# LITTLE WAKERING - KIMBERLEY ROAD

# Report on flooding issues for the Flood Forum following a site visit on 12/5/2021.

Jeff Stacey Emergency Planning Business Continuity Officer Rochford District Council

# Flood Advisory Group Little Wakering – Kimberley Road Report 4 4 DITCH

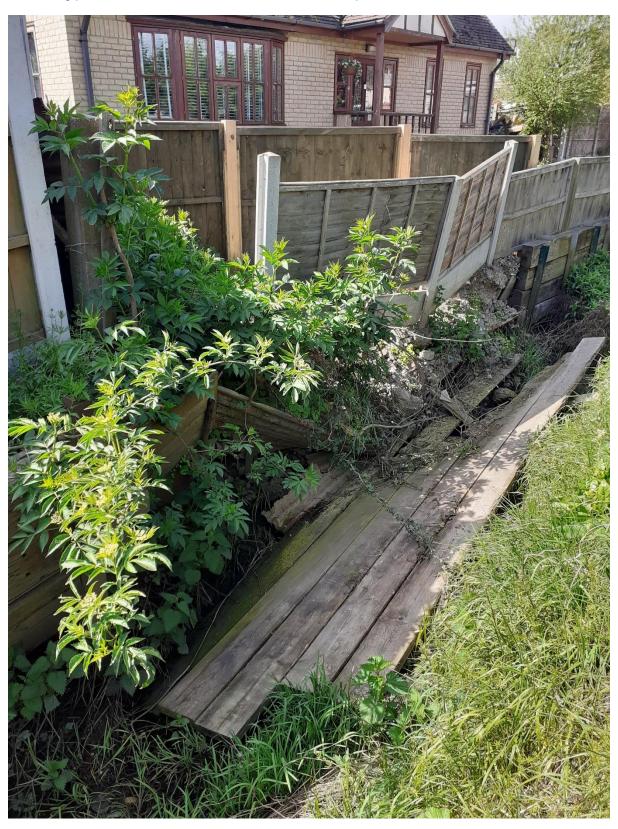
The ditch runs from Little Wakering Road to the culvert under the Sluice Gate, a distance about 30 meters. Water enters from under the road and was observed to have a steady flow even though there had been no recent rain. The conclusion is that the source is not only related to run off from the road.
